W3P82-3949
 3-J22
 Pre-Fuel Load

SUBJECT: Additional Information for License to Receive, Possess,
 and Store Special Nuclear Materials.

Appendix A
Additional Information Required for Application
to Receive, Possess, and Store Special Nuclear Materials

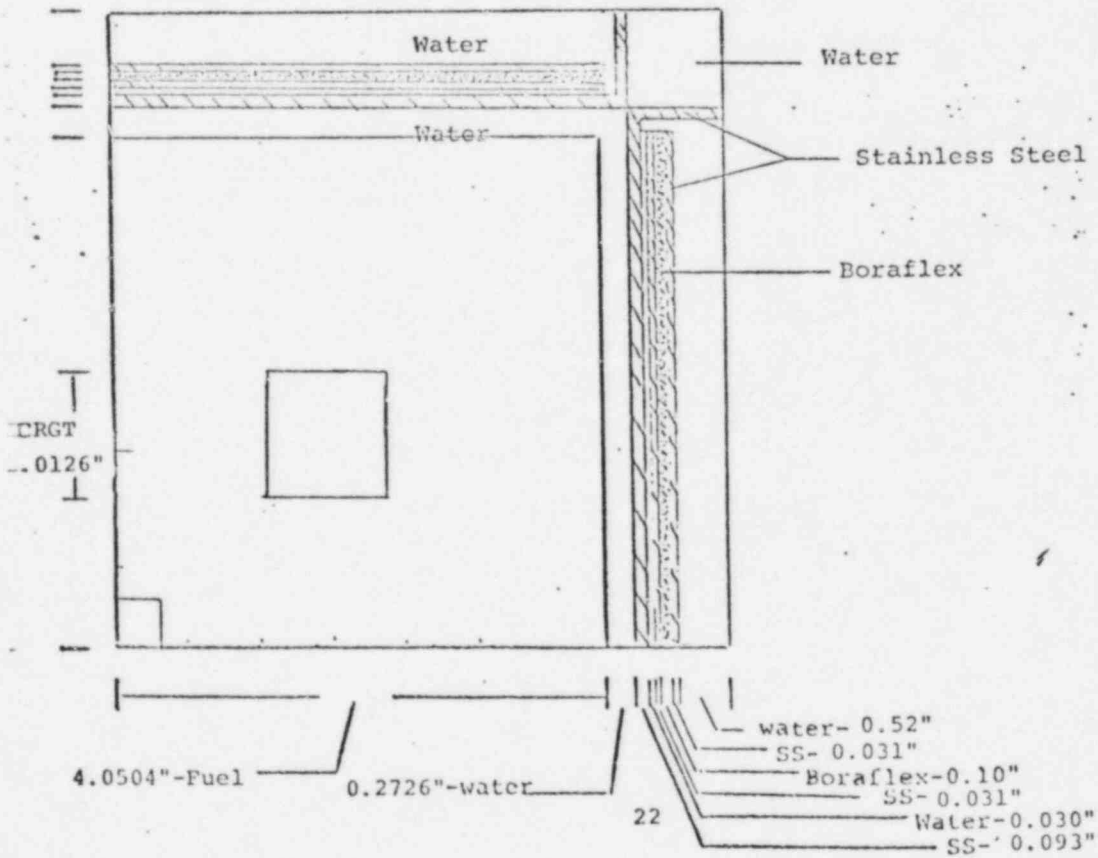
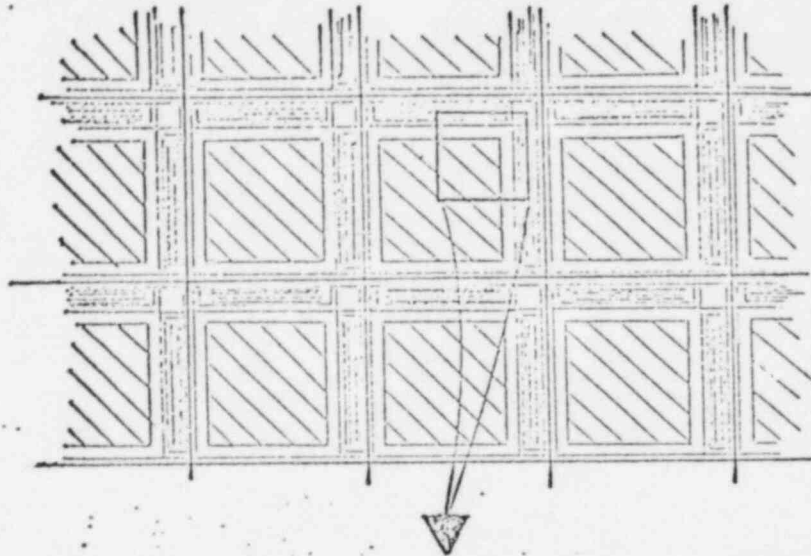
1. Please send a clear copy of Pages 22 and 23 from your March 4, 1982 supplement. It should have materials and their dimensions clearly legible.

The requested pages are attached.

FIGURE 2 - 1

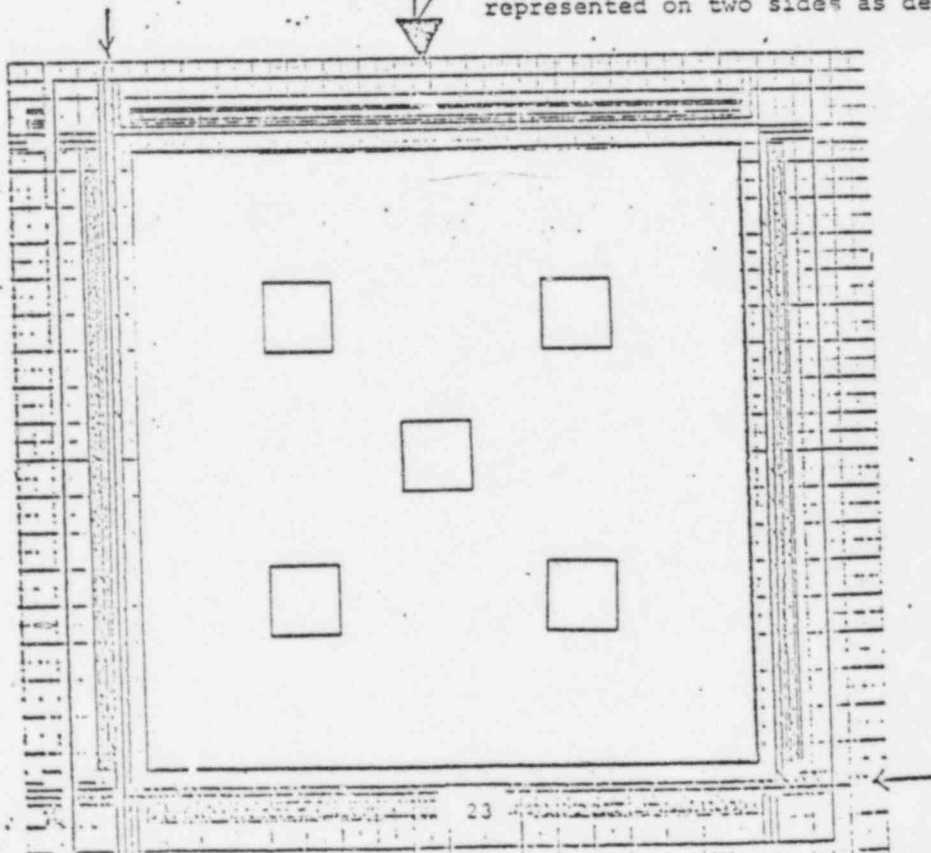
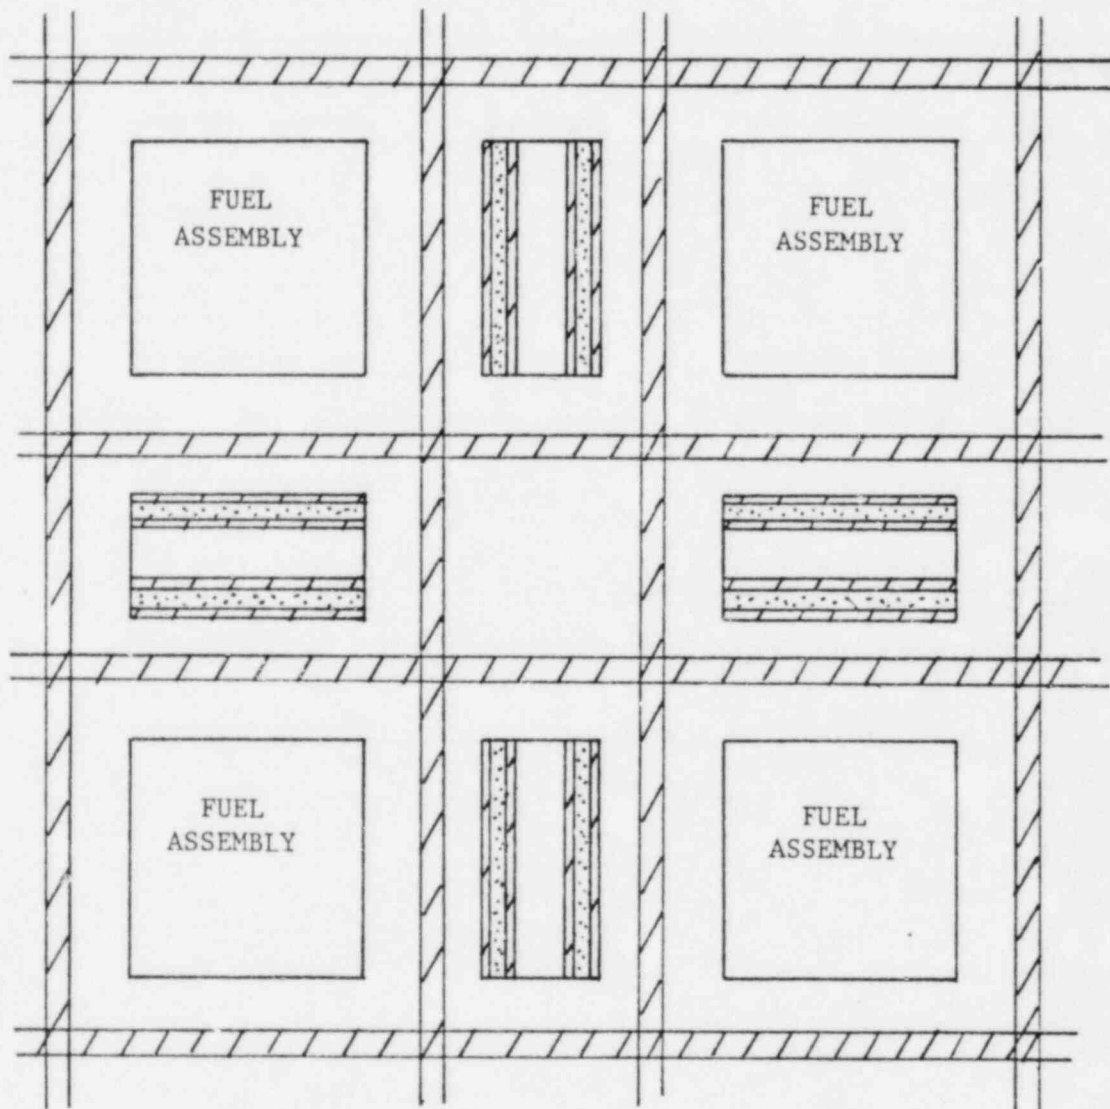
2. Please send a diagram and a description of a canned poison element, as referenced on Page 9.1-6 of your FSAR; what is an inner can? The FSAR mentions two sheets of boraflex, but the March 4 supplement shows only one layer. Please reconcile this discrepancy.

The arrangement of the spent fuel storage racks is shown in Figure 2-1. Each fuel assembly compartment is separated from one another by a neutron poison assembly compartment. Contained in each poison assembly compartment are two canned poison elements. A canned poison element consists of a 0.1 inch thick sheet of Boraflex sandwiched between two sheets of 0.031 inch thick stainless steel. This forms the "inner can" referred to on Page 9.1-6 of the FSAR. The outer can of stainless steel, which makes up the boundary of the poison assembly compartment, surrounds both canned poison elements and forms the structural container for the poison material.

The March 4 supplement shows this arrangement in the figures on pages 22 and 23. The close-up sketches are drawn on the basis of an implied symmetry. Thus, although only one boraflex sheet is shown in the close-up figure, it is repeated throughout the rack assembly design due to the symmetrical configuration. The March 4 supplement is therefore consistent with the FSAR description, in that there are two sheets of Boraflex between each assembly.
